Docket Item #
BAR CASE #2008-0076

ISSUE: Appeal of a decision of the Board of Architectural Review, Old and Historic Alexandria District approving a Certificate of Appropriateness for replacement of a front door with the condition that the door be wood rather than fiberglass

LOCATION: 209 Jefferson Street

Docket Item # 5
BAR CASE # 2008-0076

Figure 1: 209 Jefferson Street façade and existing six panel wood door with clear beveled glass in two top panels.

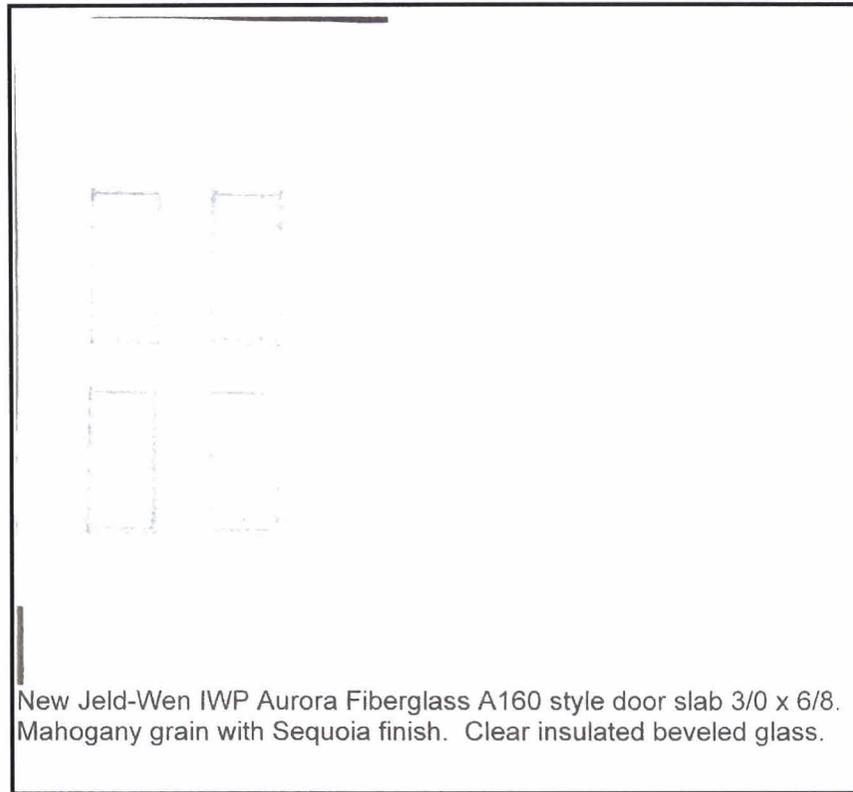
houses at 207 and 209 Jefferson was constructed using authentic historic materials such as brick exterior walls and wood front doors. Staff finds that a replacement door should retain a sense of material integrity and be compatible with the historic materials found throughout the Old and Historic District for this very prominent feature. In making its decision, the Board found that the replacement of a wooden front door with a fiberglass front door would be inappropriate.

Staff recommends that Council support the BAR decision to approve a Certificate of Appropriateness for replacement front door with the condition that the door be all wood rather than fiberglass, in the six panel with top panel glass configuration proposed by the applicant.

Figure 1 Photograph of existing front door.

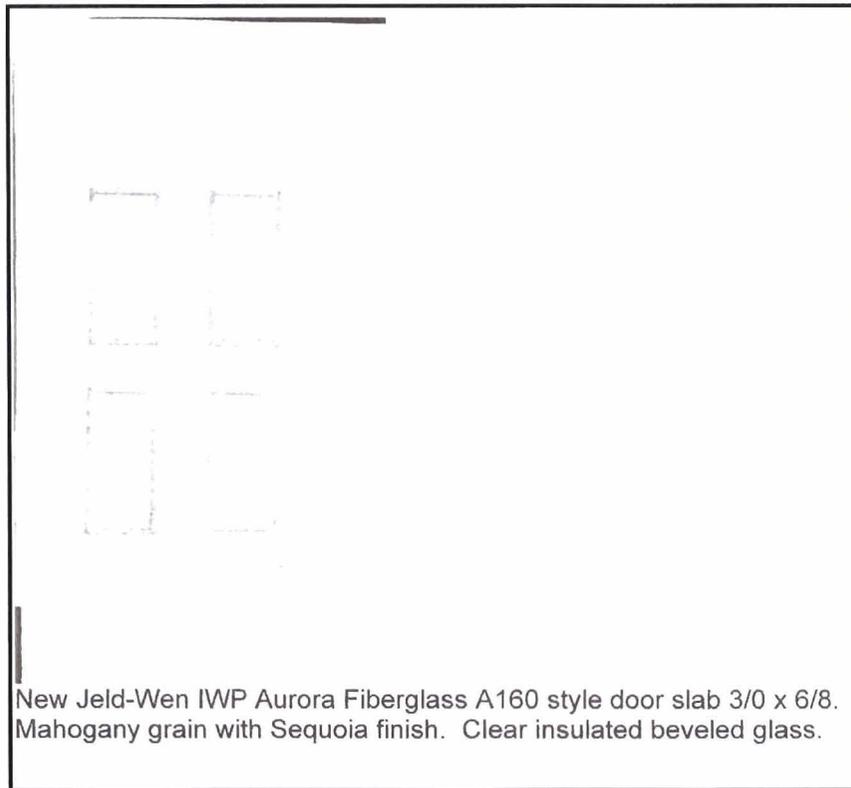
According to the *Design Guidelines* exterior doors are prominent visual details of the main façade of a building and therefore should complement the architecture of a structure. Furthermore, the guidelines state that exterior paneled metal doors are generally not appropriate on residential structures. In staff's opinion, the replacement of a wooden front door with a fiberglass front door would be inappropriate within the historic district.

Staff recommends approval of the application with the condition that the replacement door be constructed of all wood.
